Haesong Korea Ltd.

Han Complex, Bara Rangamatia, Zirabo, Savar, Dhaka, Bangladesh
(23.909859, 90.303641)
10th June, 2014

Observations

Ground Floor Column Layout

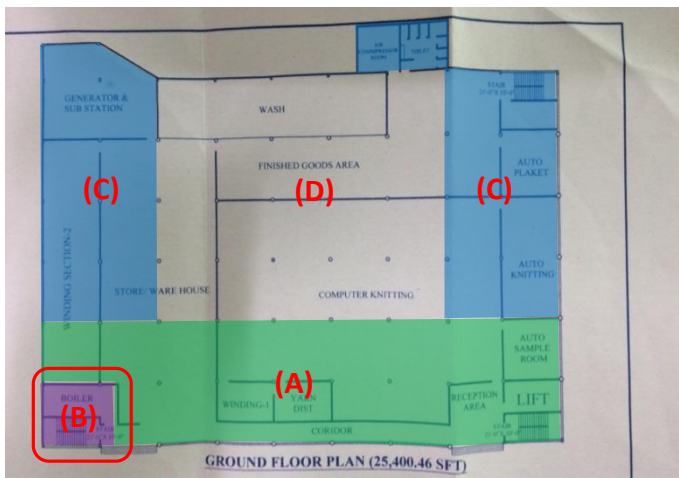
- cursory calculations indicate that column size appears to be smaller than required by code for the applied dead and live load, assuming typical concrete strength
- In the absence of testing certificates, concrete strengths are assumed based on historical BUET data.
- As built concrete strength and as built reinforcement to be surveyed and used to verify the column capacities

High concrete stress in columns

Item No.	Observation	Recommended Action Plan	Recommended Timeline
1	High concrete stress in some columns	Empty roof level water tank	Immediate - Now
2	High concrete stress in some columns	The imposed load in all areas on all levels must not exceed 1.5 kN/m ²	Immediate - Now
3	High concrete stress in some columns	Qualified Structural Engineer to review design, loads and stresses in all columns as part of a Detailed Engineering Assessment (DEA) (see scope below).	Immediate - Now
4	High concrete stress in some columns	Verify in-situ concrete strength by testing 100mm diameter cores taken from 4 no. columns (minimum). Qualified Structural Engineer to determine safe locations for coring. Prior to coring, the floor beams supported by the column should be propped through all levels to ground floor. The column reinforcement should be exposed to ensure that it will not be damaged during coring. Following coring, the column should be repaired using suitable repair mortar before de-propping the floor beams.	Immediate - Now

Weight of Tank over North-East Stair Core

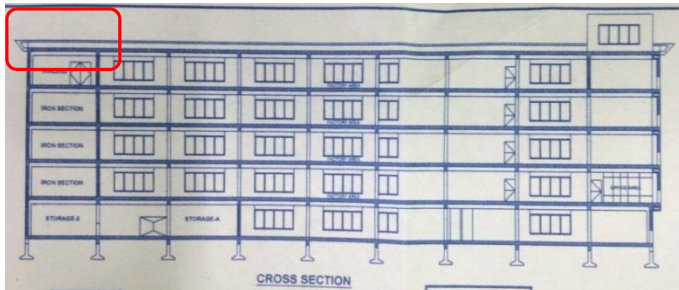
- Cursory calculations indicate that weight of roof-top concrete tank and its contents contribute significantly to the potential overloading of supporting columns, assuming typical concrete strength

Permit Drawing Cross Section

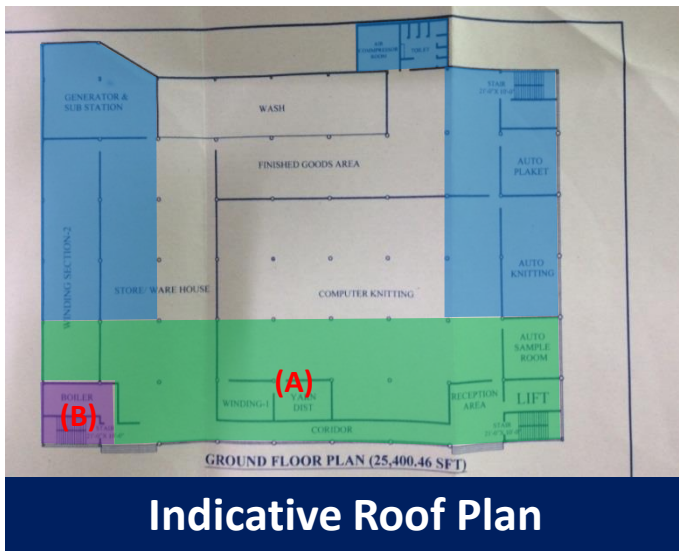
- Permit drawings show a 5 storey building and Slab & Beam construction to Roof Slab, similar to typical floor slabs, and no water tank.
- As constructed:
 - Roof slab (A) has not yet been constructed over full building footprint
 - Flat Slab has been used in lieu of Slab & Beam construction to roof slab (A)
 - North-east stair core lid (B) is higher than roof slab (A)
 - Steel roof frames have been installed to dining and prayer rooms (C)
 - Area of the Fourth Floor Slab is acting as a roof to the Third Floor (D)
 - Two additional columns constructed at 4th Floor to support Flat Slab roof edges near raised stair core lid. These columns bear on 4th Floor beams.

Building permit drawings do not match as-built building details

Item No.	Observation	Recommended Action Plan	Recommended Timeline
10	Building permit drawings do not match as-built building details: * North-East Stair Core Lid and Concrete Roof * Metal roof frames to Dining and Prayer Rooms * Childcare and Residence Building	Building engineer to check, collect information and produce accurate and complete as-built documentation as part of the Detailed engineering Assessment (refer to item 1 above).	6-weeks
11	Building permit drawings do not match as-built building details: * North-East Stair Core Lid and Concrete Roof * Metal roof frames to Dining and Prayer Rooms * Childcare and Residence Building	Building Engineer to review as-built structure and if required, prescribe relevant structural improvements to ensure these meets BNBC requirements for stability, strength and serviceability under all gravity and lateral loads	6-weeks
12	Building permit drawings do not match as-built building details: * North-East Stair Core Lid and Concrete Roof * Metal roof frames to Dining and Prayer Rooms * Childcare and Residence Building	Building Engineer to develop accurate and complete as-built structural drawings	6-months

Raised stair lid and tank over to North-east stair core

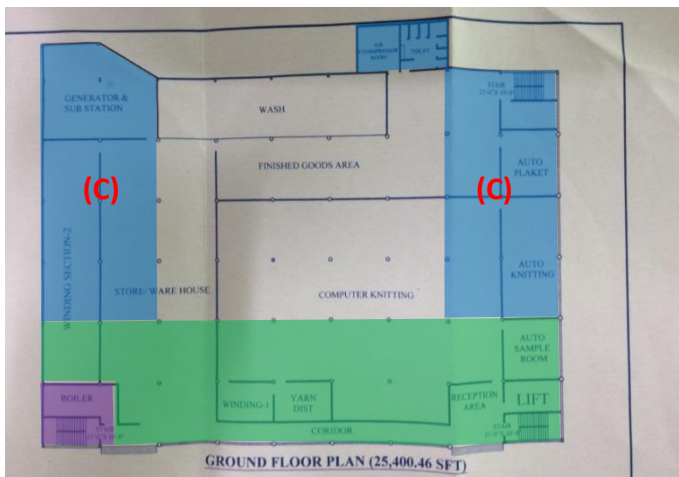
- Minor differential movement observed to short infill walls between main roof slab (A) and stair core lid (B)
- No moment continuity exists between the two roof surfaces
- Two columns constructed to support main roof slab bear on Fourth Floor beams
- Minor flexural cracking observed to main roof slab (A) approximately between additional columns

Additional columns to main roof slab (A) near stair core (B)

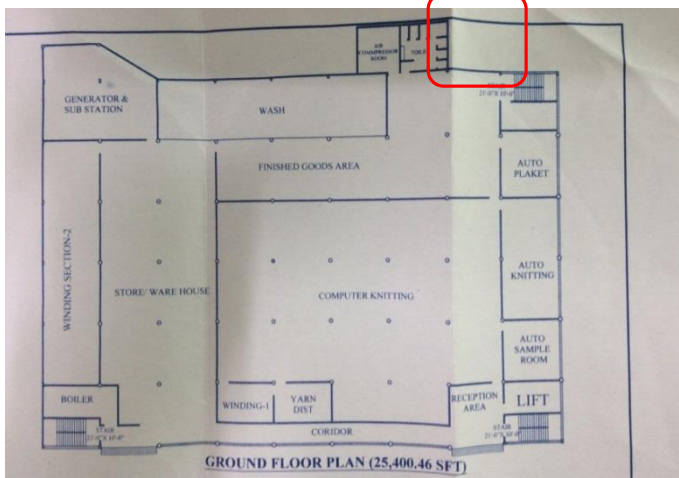
- Light metal roof frames have been installed over columns and walls to prayer and dining areas
- Lateral stability and tie down details do not appear to be engineer-designed

Building permit drawings do not match as-built building details
